PLANNING COMMISSON REGULAR MEETING AGENDA

400 Sixth Street	July 6, 2026	7:00 PM
-------------------------	---------------------	----------------

Subject: Market + The Graham/265 E. 2nd Street/Amendment #3; Site Plan Review;
Revised Site Plan and Supplemental Letter Dated June 4, 2026.

Architectural
Site Plan

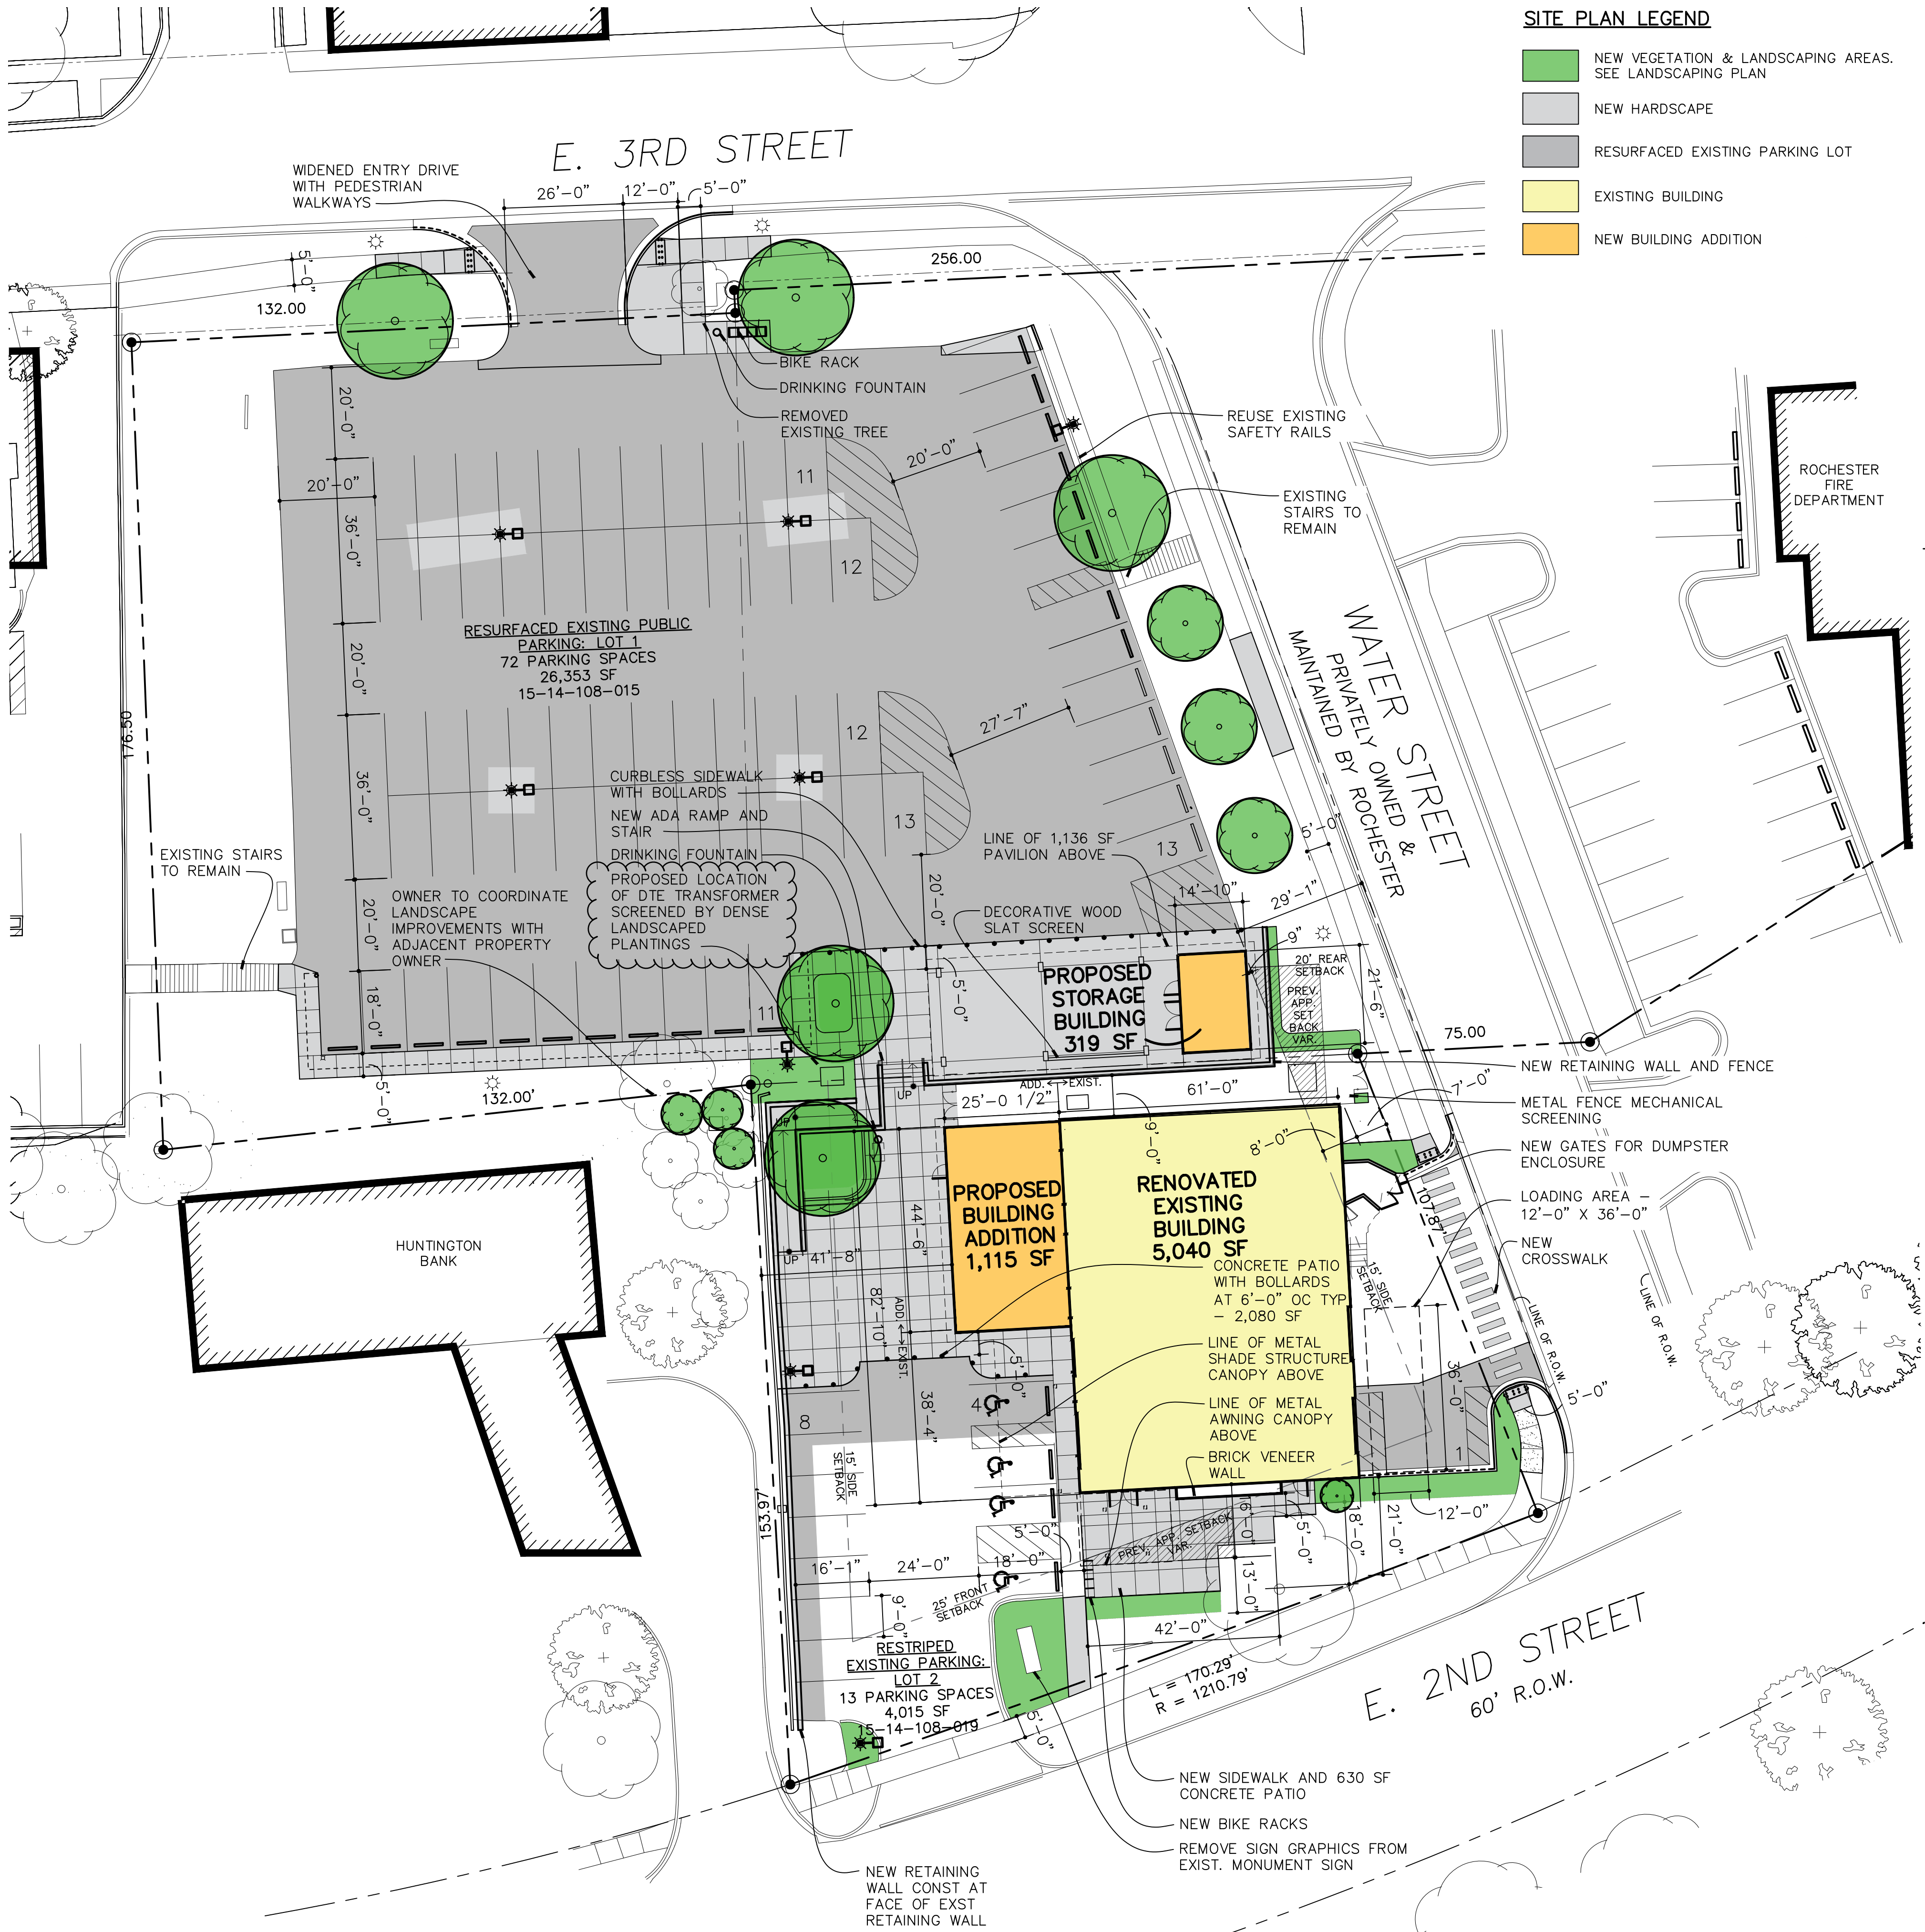
7. **Parking and Loading.** Proposed parking and loading are unchanged from the previous amendment. The plan at this time proposes occupancy of 311 people, resulting in a parking

requirement of 78 spaces. The site plan shows a total of 85 spaces including 4 handicap accessible spaces. *The plan notes that during events, no parking spaces will be available on either lot.* Loading/unloading activity will take place on the east side of the existing building as previously approved and is shown to be located fully within the subject site.

Overall Landscape Plan

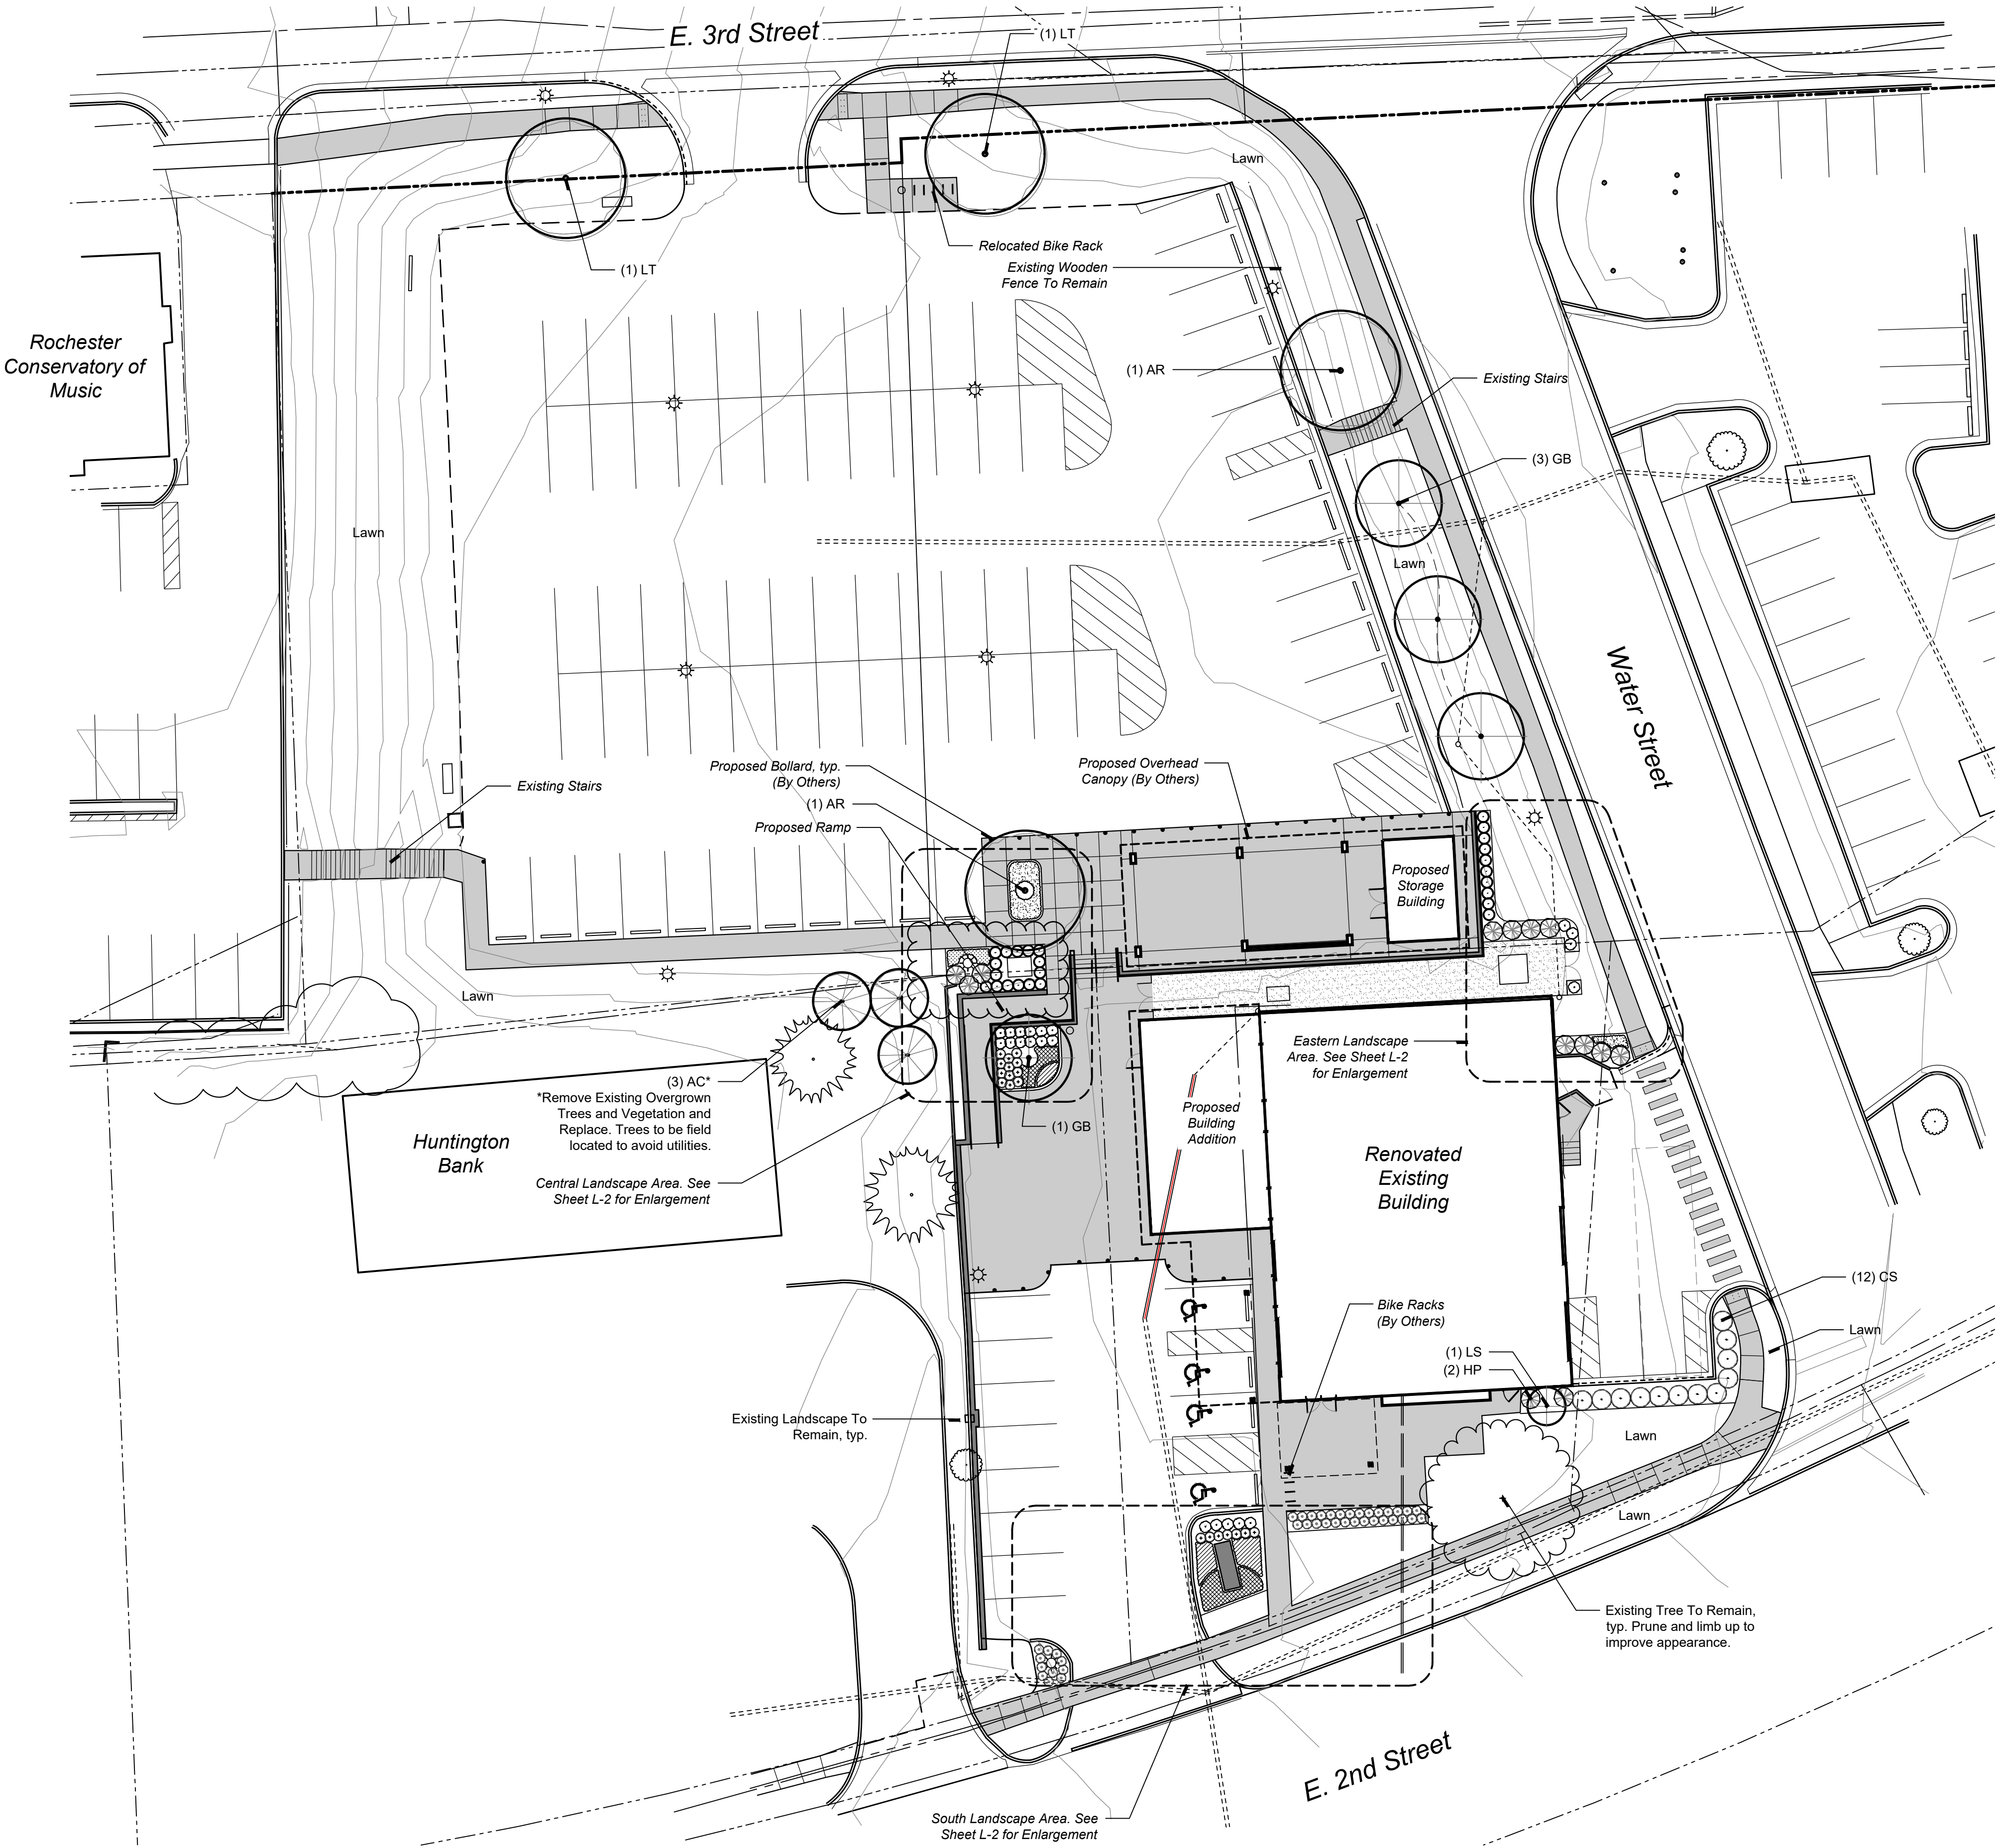
4. **Landscaping.** The previously proposed landscaping has been reconfigured to establish vegetation screening around the relocated DTE transformer. The screen is formed by fifteen Karl Foerster Feather Reed Grasses. These plants were included in the previous plan but have been repositioned to form the screen. This change does not change previous compliance with the landscaping requirements of the zoning ordinance.

MARKET + THE GRAHAM
PHOTOMETRIC SITE PLAN
GASSER BUSH ASSOCIATES
PREPARED FOR: AUGER KLEIN ALLER ARCHITECTS
WWW.GASSERBUSH.COM

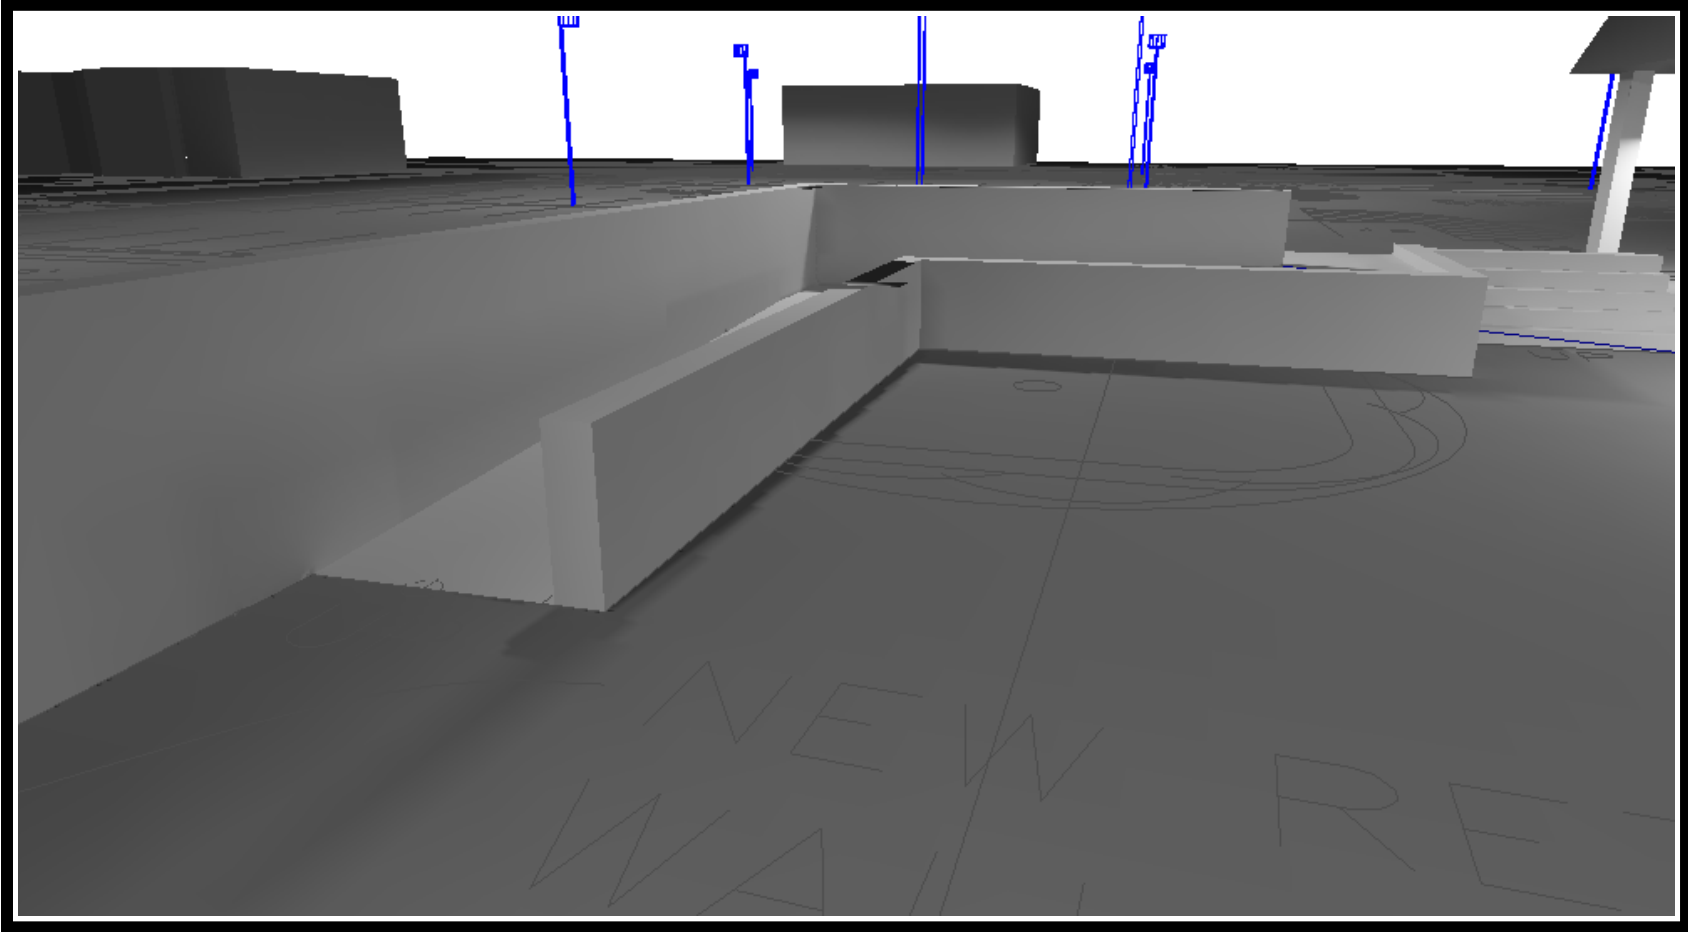
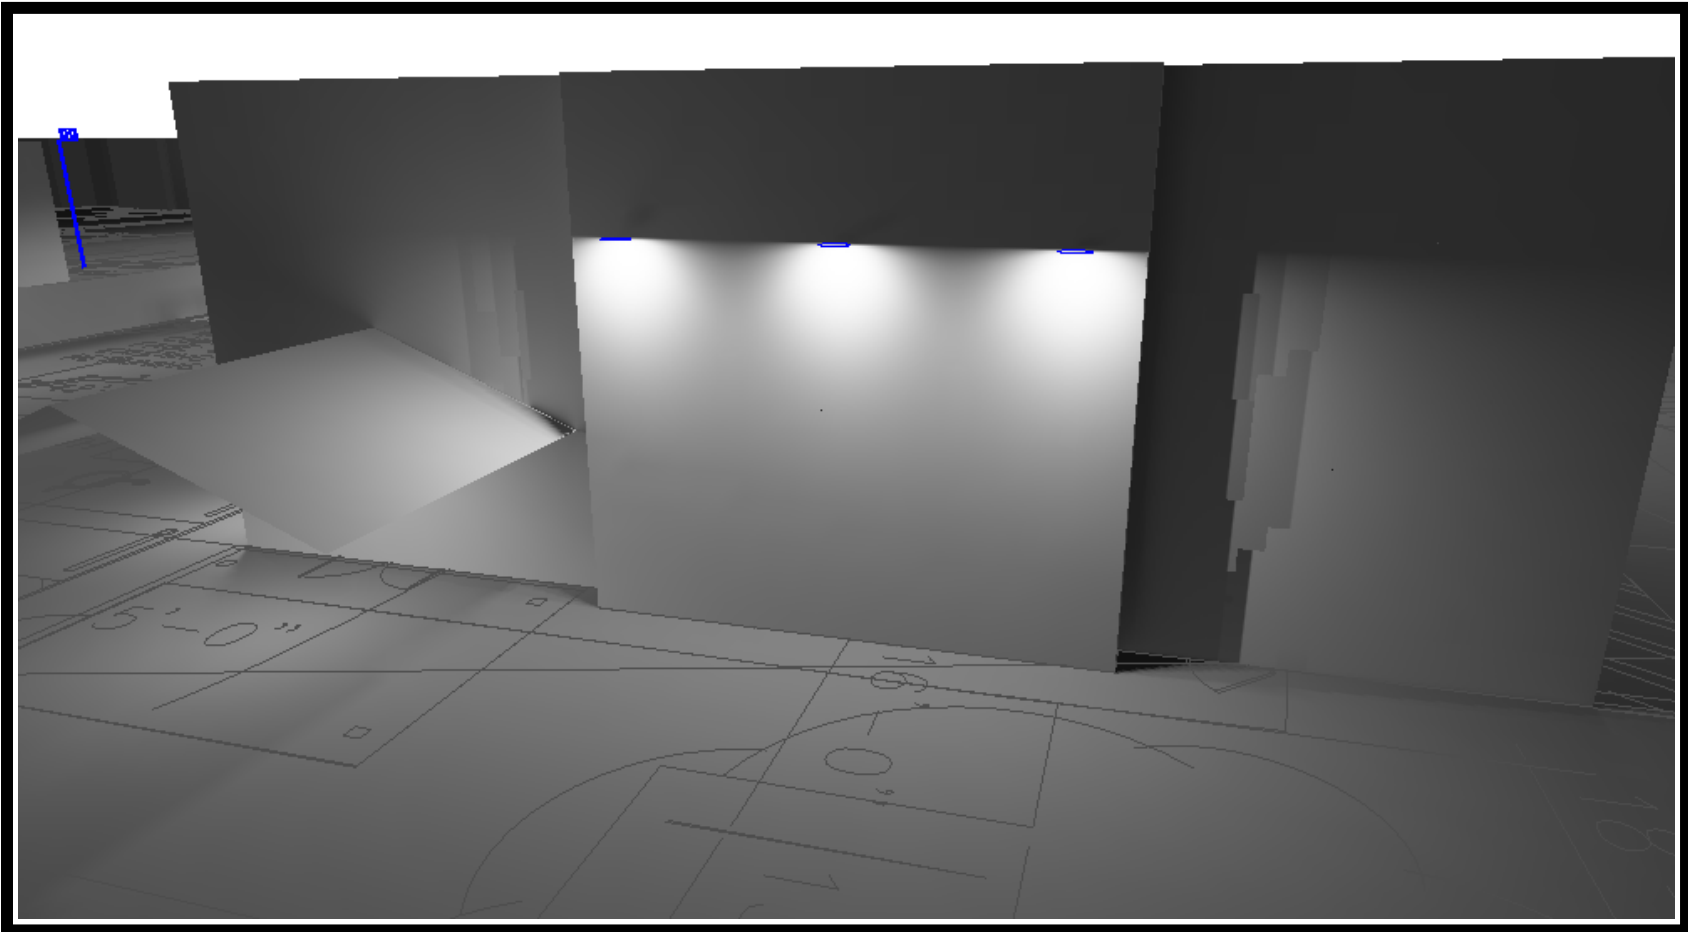
8. **Lighting.** A detailed photometric plan has been submitted that complies with Section 2306 of the zoning ordinance. It appears that the fixtures have been changed from the previous plan, but the cut sheets provided indicate that the currently proposed fixtures comply with the ordinance and are still consistent with the proposed design.
